Subject: Limerick Generating Station Unit 2
Technical Specifications Change Request No. 99-05-0

**TECHNICAL SPECIFICATIONS CHANGE REQUEST
NO. 99-05-0**

LGS UNIT 2

BASES FIGURE B 3/4.3-2

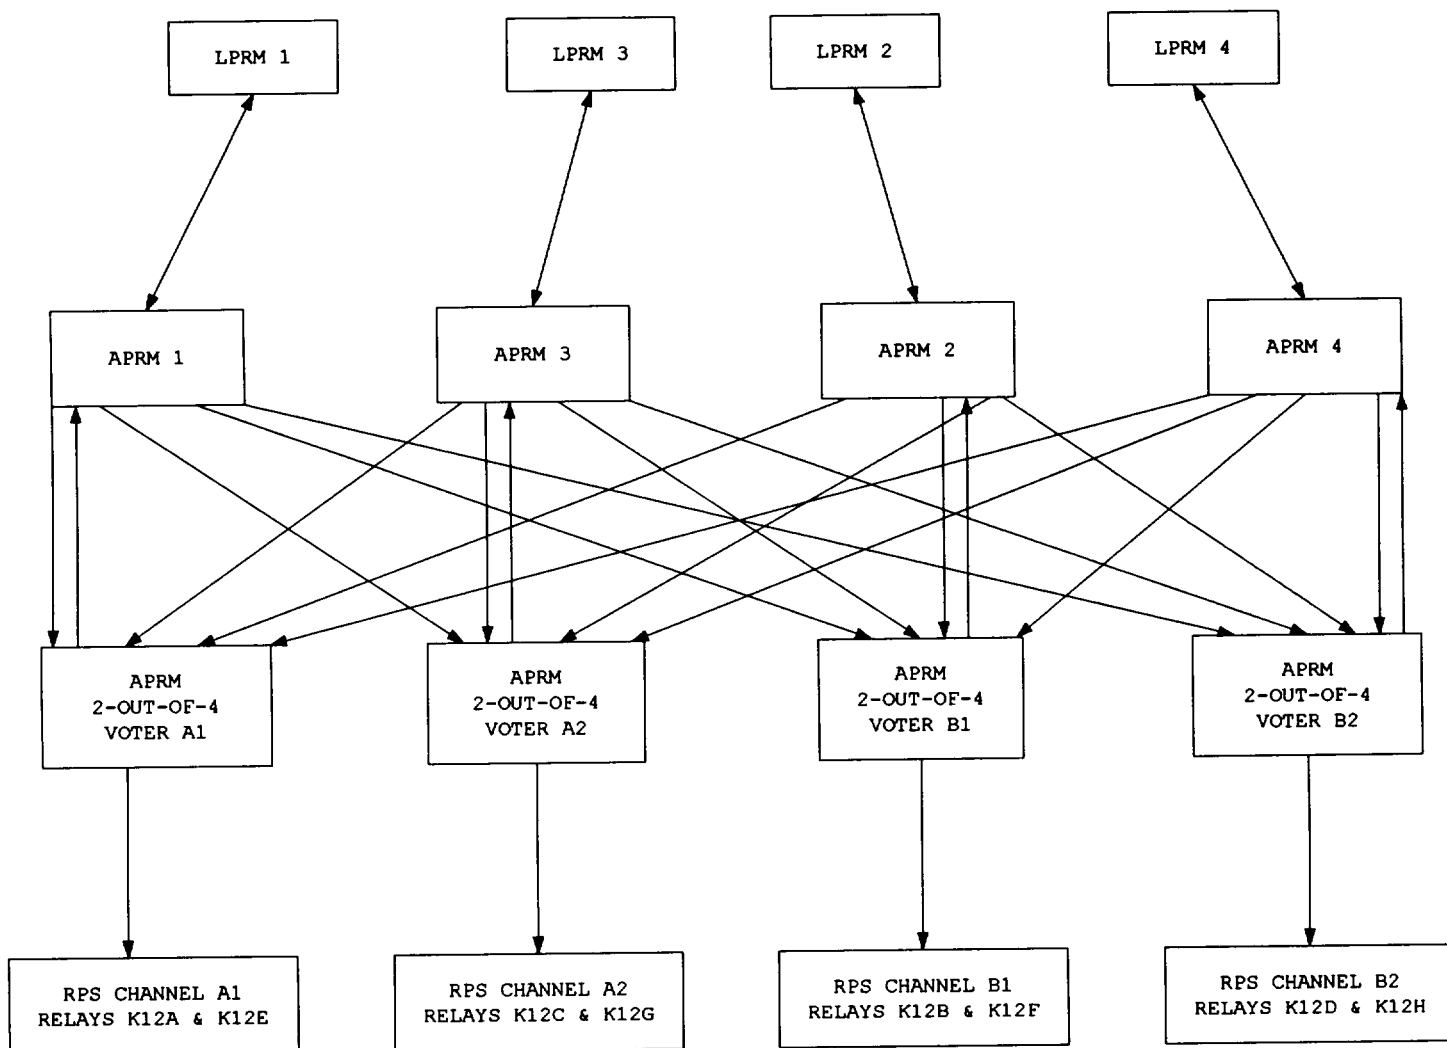
The Two-Out-Of-Four Logic Module includes 2-out-of-4 voter hardware and APRM Interface hardware. The voter Function 2.e is accomplished by the 2-out-of-4 voter hardware which includes redundant outputs. The analysis in NEDC-32410P-A took credit for this redundancy in the justification for the 12-hour allowable out of service time, so the voter Function 2.e must be declared inoperable if any of the 2-out-of-4 voter hardware's functionality is inoperable. The voter Function 2.e does not need to be declared inoperable due to any failure affecting only the APRM Interface hardware portion of the Two-Out-Of-Four Logic Module.
